**§ 68.308 Signal power limitations.**

(Reworded, Delete and Changed)

**§ 68.308(b)(1)**

Figure 68.308 (e) Ref. EIA/TIA 547-1989)

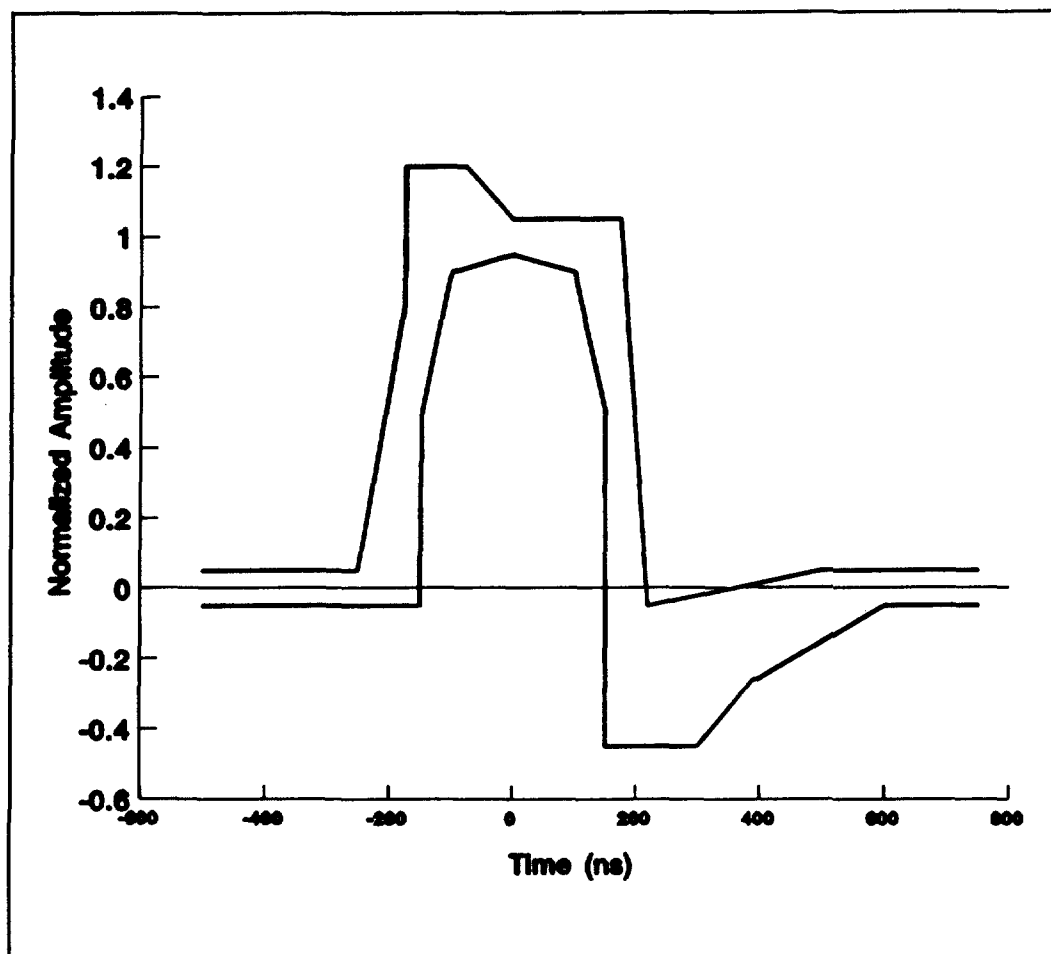
(a) *Option A output pulse.* When applied to a 100 Ohm resistor, the instantaneous amplitude of the largest output pulse obtainable from the registered terminal equipment shall fall within the pulse template illustrated in Figure 68.308(e). The mask may be positioned horizontally as needed to encompass the pulse, and the amplitude of the normalized mask may be uniformly scaled to encompass the pulse. The baseline of the mask shall coincide with the pulse baseline.

(b) *Option B output pulse.* When applied to a 100 Ohm resistor, the instantaneous amplitude of the output from the registered terminal equipment obtained when Option B is implemented shall fall within the pulse template obtained by passing the bounding pulses permitted by Figure 68.308(e) through the following transfer function.

(c) *Option C output pulse.* When applied to a 100 Ohm resistor, the instantaneous amplitude of the output from the registered terminal equipment obtained when Option C is implemented shall fall within the pulse template obtained by passing the pulses obtained in Option B through the transfer function in Option B a second time.

*The harmonized pulse mask for Option A (no LBO) was changed to the mask for DS1 equipment as found in EIA/TIA 547-1989 Standard. This mask is intended for equipment output and is less restrictive in terms of pulse amplitude (3.6 V allowed instead of the current Part 68 of 3.3 V for this option).*

Figure 68.308(a)

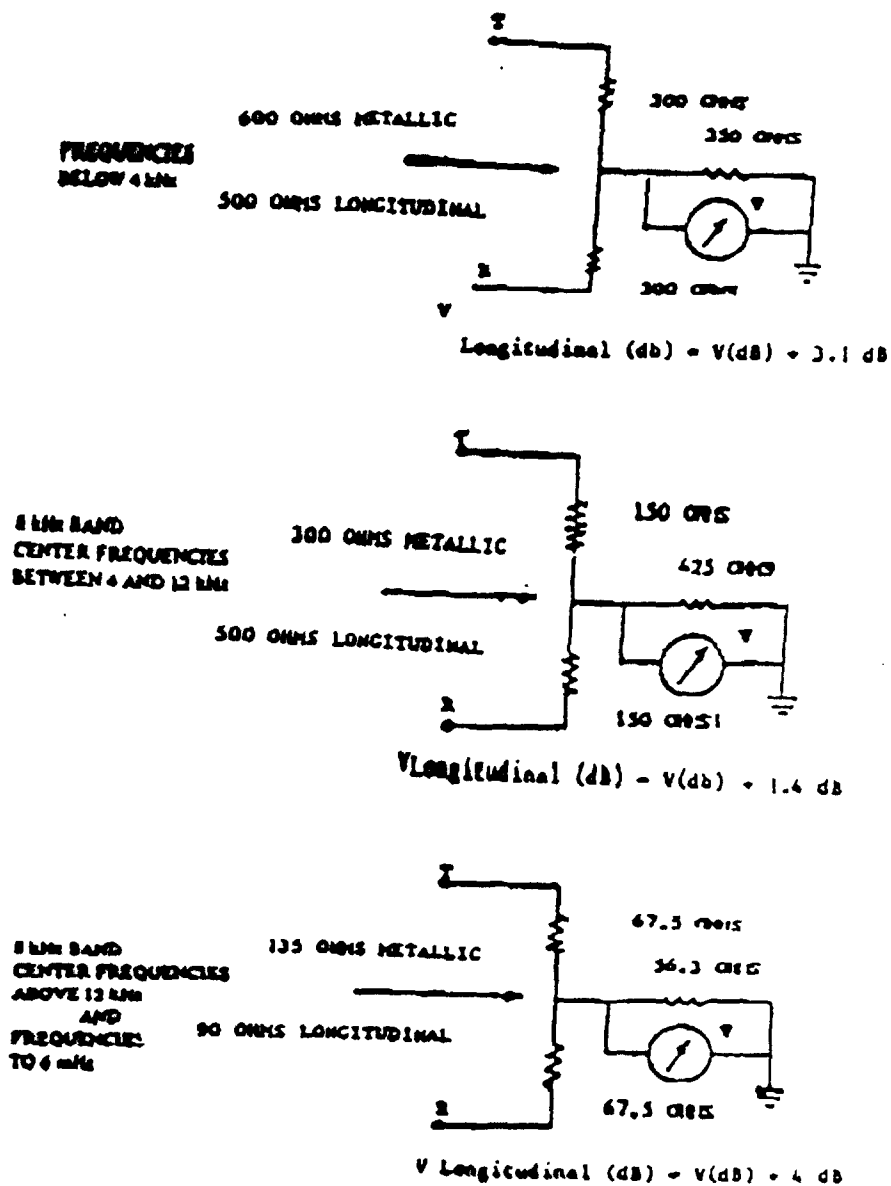
(1) All registered terminal equipment, except equipment to be used on LADC, and all registered protective circuitry must comply with the limitations when connected to a termination equivalent to the circuit depicted in Figure 68.308(b) and when placed in all operating states of the equipment except during network control signaling. ~~For message registration in the ground return mode, a termination equivalent to Figure 68.308(c) is required, and metallic voltage limitations do not apply.~~ LADC registered terminal equipment must comply with the metallic voltage limitations when connected to circuits of § 68.3(k) and must comply with the longitudinal limitations when connected to circuits of Figure 68.308(a), as indicated.

*This section has been reworded to delete the reference to message registration. Figure 68.308(c) has been deleted and Figure b has been renumbered and the title changed to reflect its revised status.*
